## Thor Motor Coach Recall Repair Instructions

Recall #	<b>17V-844</b>		
Description/Title:	<b>A27 Heat Shield</b>		
Affected Product Line(s):	<b>Certain 2018 A27 Freedom Traveler motorhomes</b>		
Service Campaign # :	<b>RC000150</b>	Released Date:	<b>01/09/2018</b>
Repair Code:	<b>TMCRC80471V</b>	Document Date:	<b>01/09/2018</b>
Time Allowed:	<b>0.75</b>	Document Revision:	<b>A</b>

DRAWING NUMBER: TFM4937

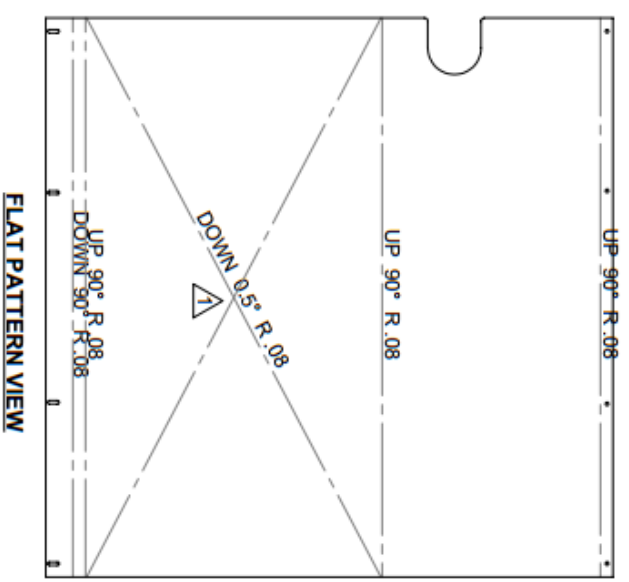
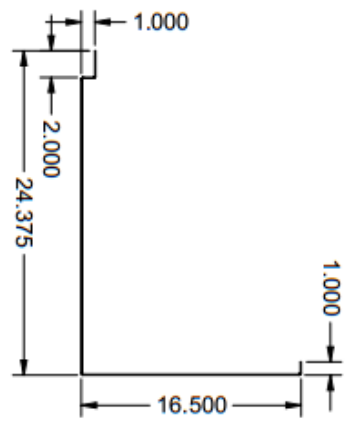
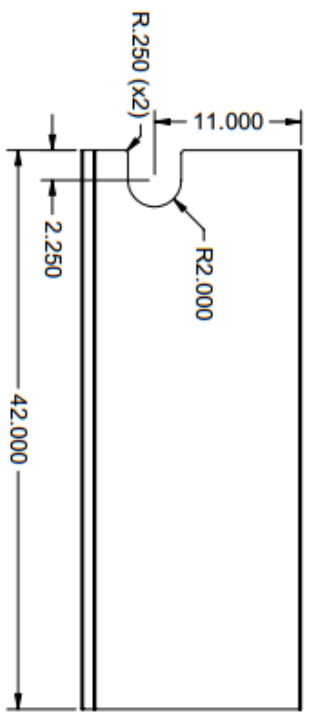
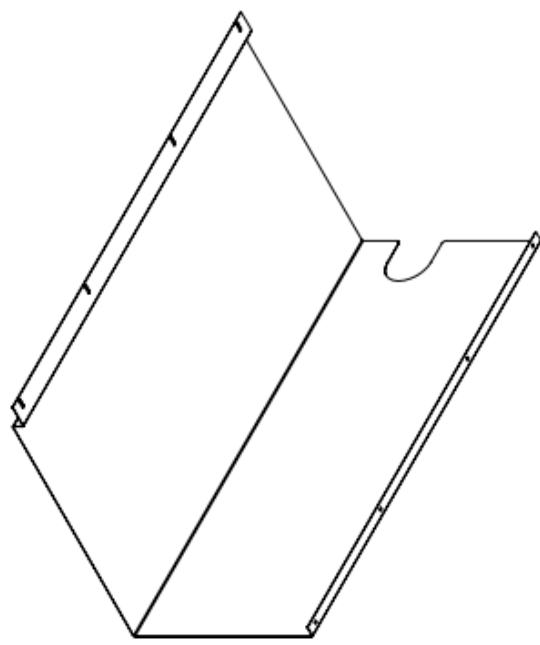
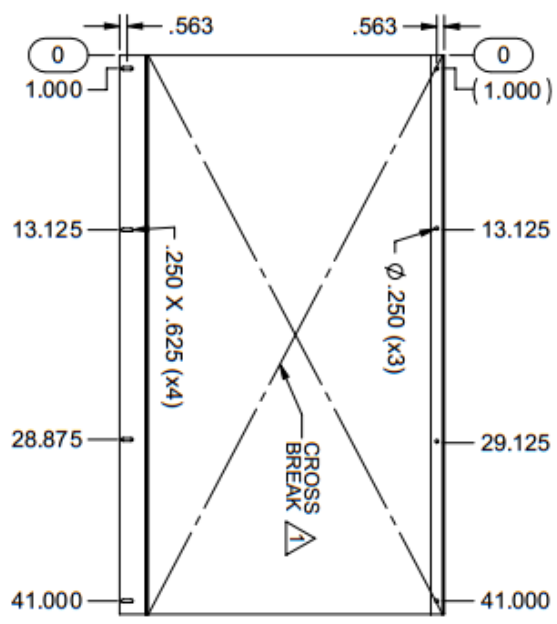
It has been discovered that on certain A27 Freedom Traveler motorhomes, a heat shield was not installed in between the LP tank and generator exhaust.

TMC Part Number **0392962**  
(See Print TFM4937)
